R STEPHENSON N<sup>o</sup> 110

PROFILE

S.S. EDMONTON

PROFILE.

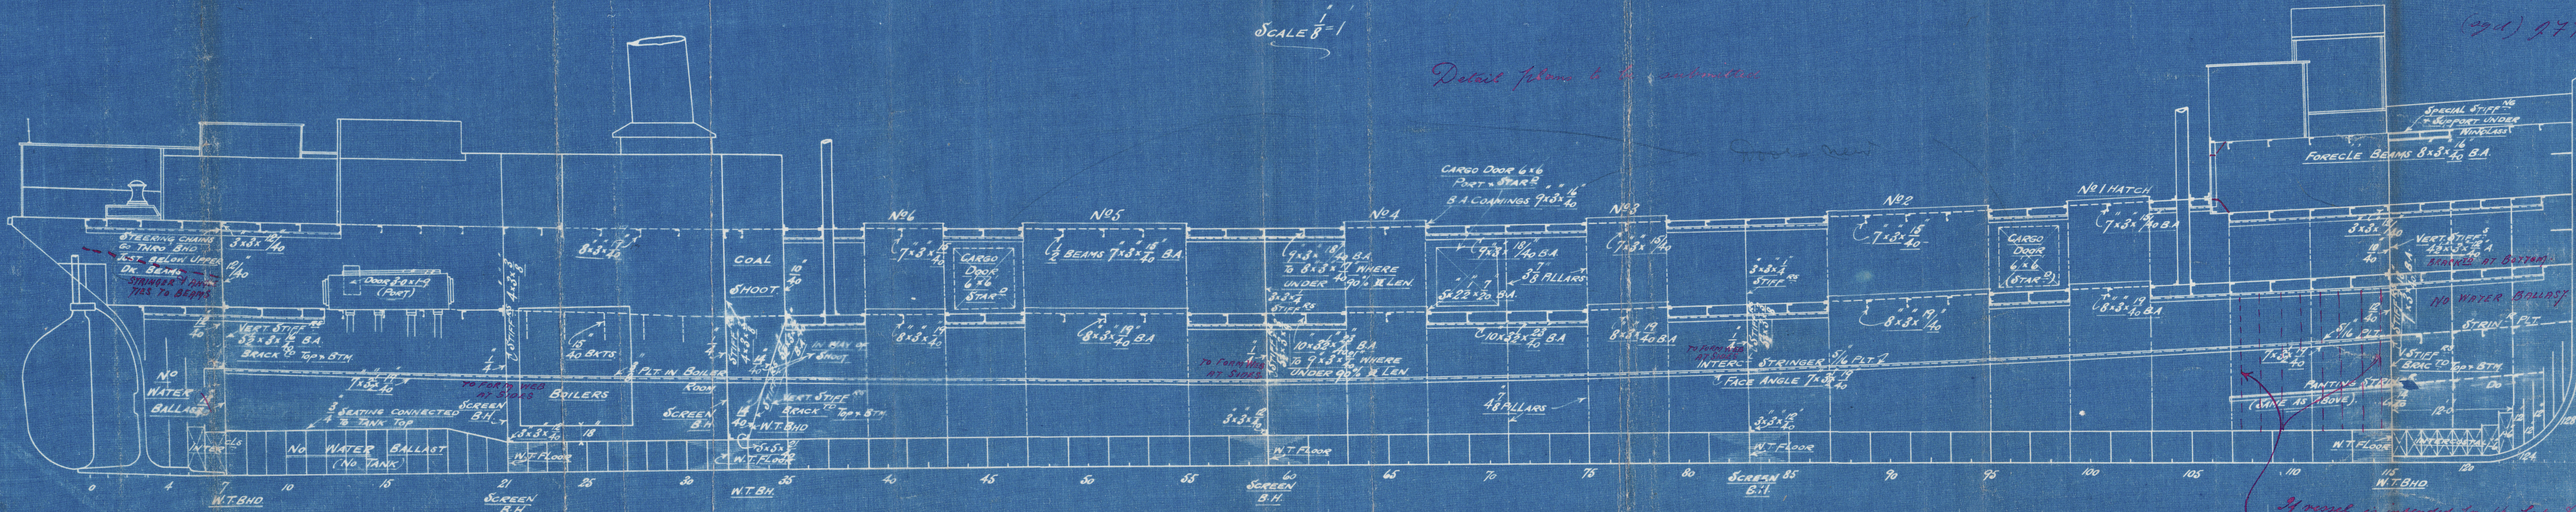
Detail plans to be submitted

Approved  
See letter No 2-6  
(sig'd) J.T.K.

If vessel is intended for the Lake & Canal service it is recommended that shell stiffening angle be fitted in each frame space as shown from No 7 frame to 115' extending on height from above line up to new gunwale.
